Responses to comments posted by Referee #2

We thank the second referee for reviewing our manuscript and providing insightful feedback. Several unclear issues were clarified. We also appreciate detailed minor comments, which helped to improve the manuscript. From minor comments we accepted the vast majority of the suggested stylistic changes. The manuscript was checked by native speaking proofreader and we followed the AMT manuscript preparation instructions. We answer all comments in the following text. Our answers are in blue.

Figure 11: Influence of time aggregation (1, 5, ~~10~~, 15, ~~and~~ 30 and 60 min) on (left) correlation and (right) RMSE in mm h⁻¹.

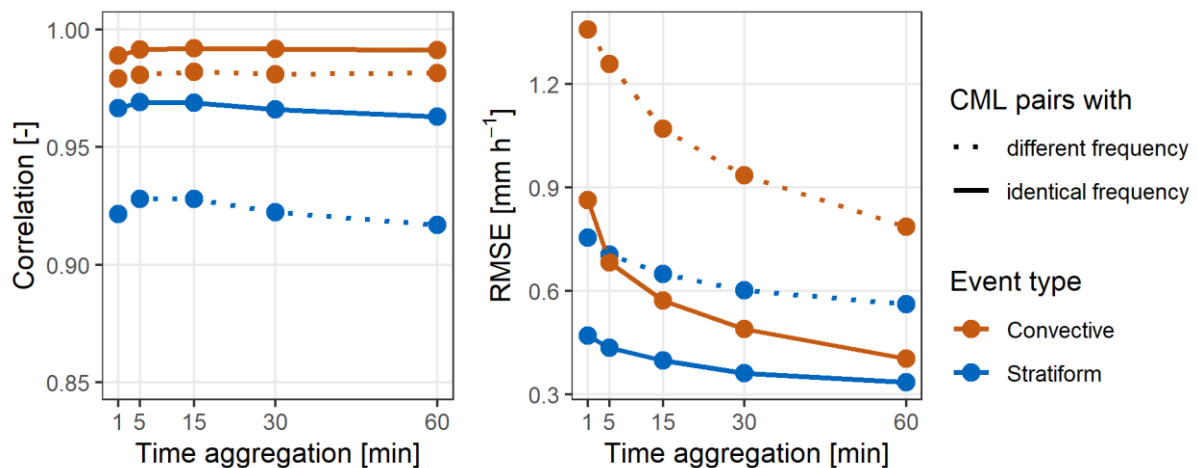
– pag. 11, line 323: Instead of analyses for 10 – min aggregations, I'd prefer to see aggregations at 1 – h. In practical applications 5 and 15 – min aggregations are near enough

(to 10 – min). Nevertheless, having hourly aggregates/estimates would allow comparisons with other rainfall products (e.g., satellite).

Agreed. We have changed the figure and modified the text in the manuscript accordingly. The changes in the original text (lines 197 ff) are in red:

RMSE and correlation were calculated for time aggregations of 1, 5, ~~10~~, 15, ~~and~~ 30 and 60 min (Fig. 11) for both rainfall types (convective and stratiform) and for both types of sites (sites “a” including the sites with identical frequency band CMLs, and sites “b” with CMLs with different frequency bands). The aggregation brings a reduction of noisiness. The correlation coefficient is consistently greater than 0.92. The increase in correlation is more pronounced for the time aggregation between 1 and 5 min. Further aggregation did not bring any additional improvement in this performance measure. The agreement of devices expressed as RMSE improves particularly quickly for convective rainfall types in aggregation between 1 and 105 min from RMSE 0.9 mm h⁻¹ to 0.6 mm h⁻¹ for pairs of identical frequency bands, and from 1.3 mm h⁻¹ to 1.1 mm h⁻¹ for pairs of different frequency bands. Stratiform rainfall types do not rapidly improve in RMSE with greater time aggregation, but the enhancement occurs linearly with greater time aggregation. On the other hand, for convective rainfall types improvement accelerates, and ~~further~~, it is even more pronounced for CML pairs at an identical frequency band.

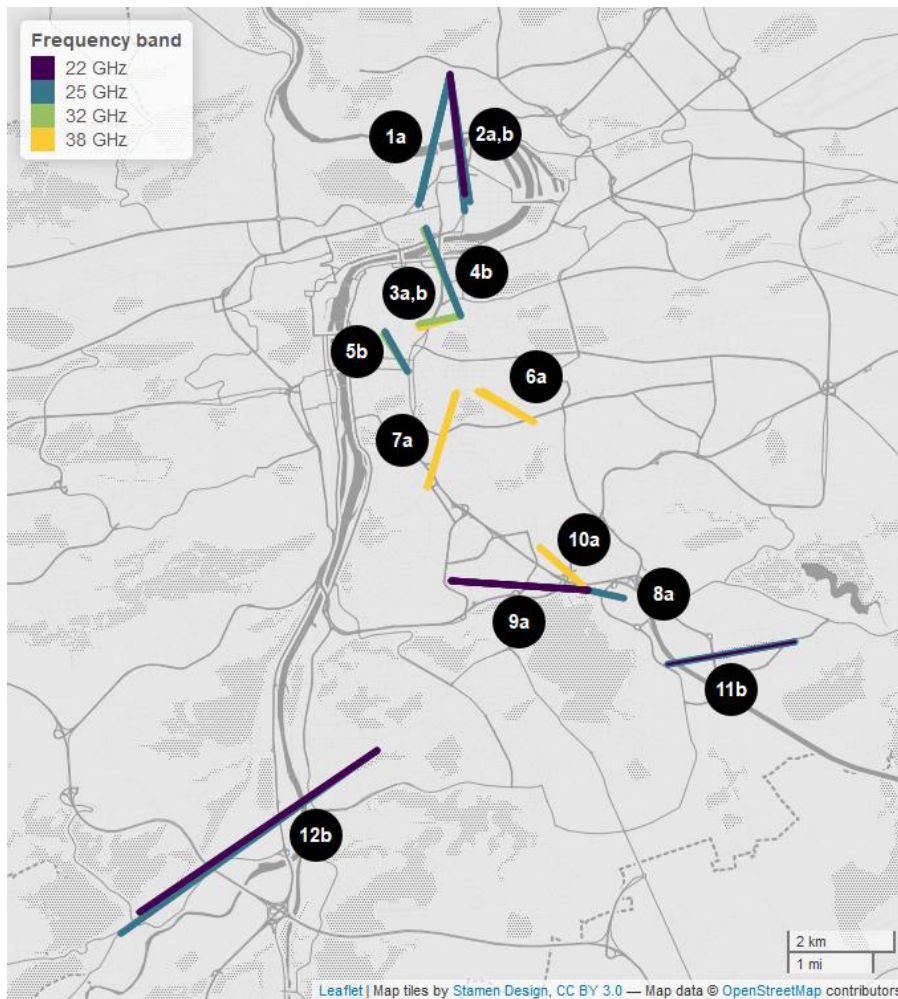
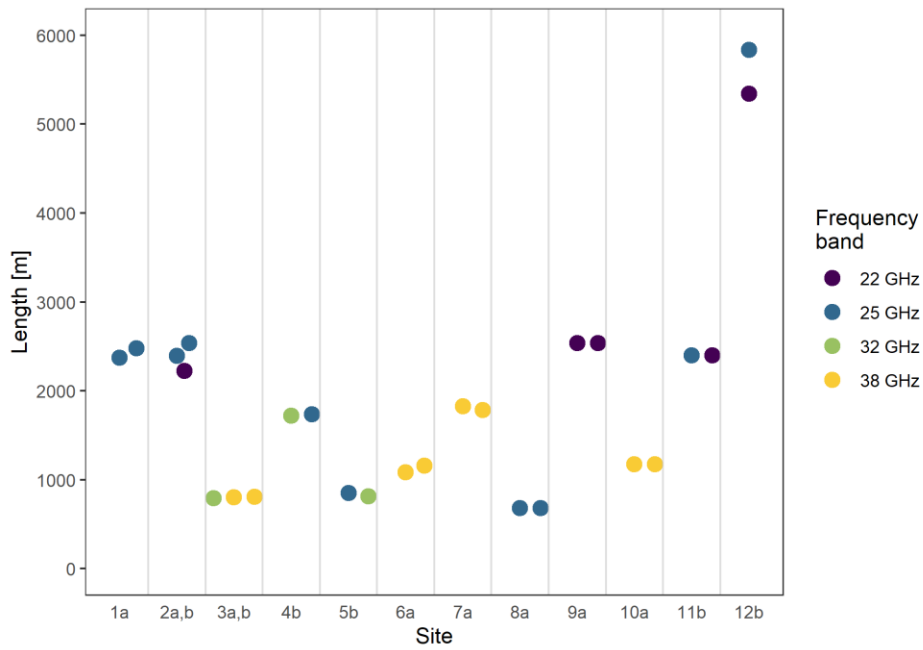
– pag. 18, line 515: Replace ‘and “b”’ by ‘whereas “b”’. I also suggest a change in the color scale. It’s hard to distinguish those CMLs in yellow.

Replaced. We changed the hue for the highest frequency band and also in Figure 2 to keep the color scale the same. Please see the figures below.

Figure 4: Example of a time series of collocated independent sensors *in-group at site 2a* for (~~topgreen~~) rain-induced attenuation and (~~bottomblue~~) rainfall intensity on 21st July 2014.

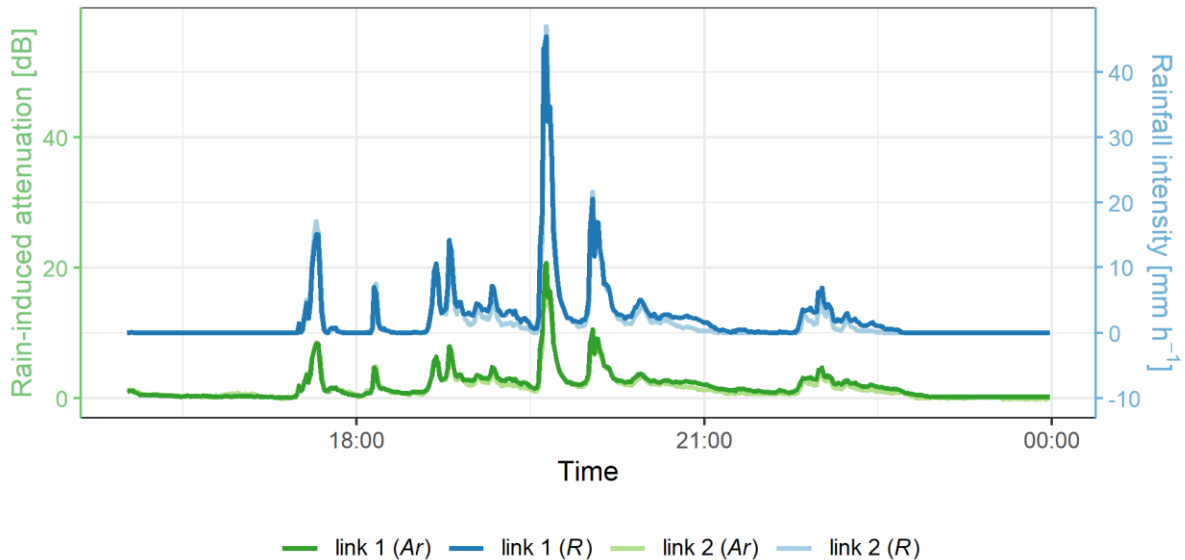
– pag. 20, Figure 4: I think these two sub-figures/panels could be join into only one figure, by having a secondary Y-axis (on the right) representing either rainfall intensity or attenuation

Thank you for the suggestion. Please see the figure and its caption below.
